This is to certify that BLUE HOUSE LLC / Robert C. Kelly & Co. Inc.  
 has permission to install on loading dock connected w/ permit 091158 walk in cooler shed roof & free standing compressor located in basement  
 AT 559 BRIGHTON AVE City of Portland 184 D026001

**City of Portland, Maine - Building or Use Permit Application**

Subject: Rosemont Market located at 559 Brighton Ave., Portland, Maine  
Exterior Free Standing Loading Dock

## HERMETIC COMPRESSORS

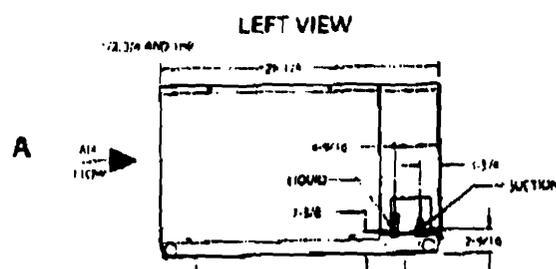
<b>Comments:</b>
10/26/2009-amachado: Spoke to Robert Connolly. Need spec sheet from compressor manufacturer that shows the sound decible of the compressor at the property line. Moving permit forward with tpermit #09-1158 to be reviewed together.
10/29/2009-amachado: Received spec sheet for compressor. Says that the dba is 58. The maximum decibel at the lot line has to be 55. The spec sheet says that it is 58 decibels. Since it is in the basement and located approximately 16' from the rear lot line, it should meet the sound volume requirement.
11/17/2009-jmb: Left msg for John N. To call, advised to call contractor. Spoke with Robert C. About details, verified no frost protection and the structure will be independent of the main building except for the flashing at the roof and the closed cell insulation in the new wall next to the building. Ok to issue when sp exemption is approved.
11/17/2009-gg: received granted site exemption. Filed with permit. (Jeannie). /gg

10'x10' WALK in Cooler

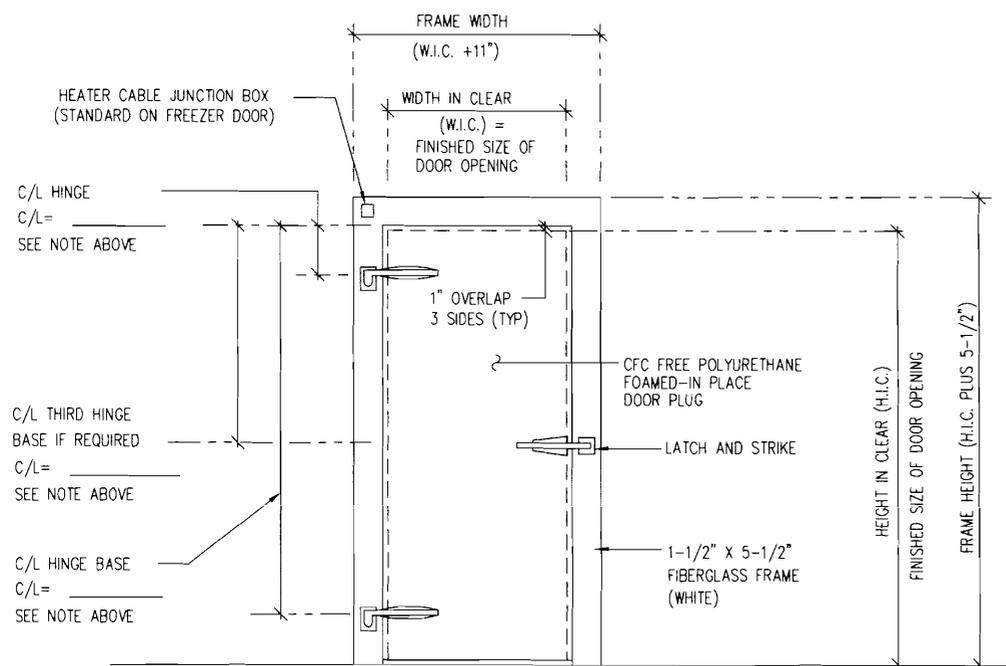
1) Permit approved based on the plans submitted and reviewed w/owner/contractor, with additional information as agreed on and as noted on plans.			
2) Separate permits are required for any electrical, plumbing, sprinkler, fire alarm or HVAC or exhaust systems. Separate plans may need to be submitted for approval as a part of this process.			
<b>Dept:</b> Fire	<b>Status:</b> Approved with Conditions	<b>Reviewer:</b>	<b>Approval Date:</b> 10/27/2009
<b>Note:</b>	<b>Ok to Issue:</b> <input checked="" type="checkbox"/>
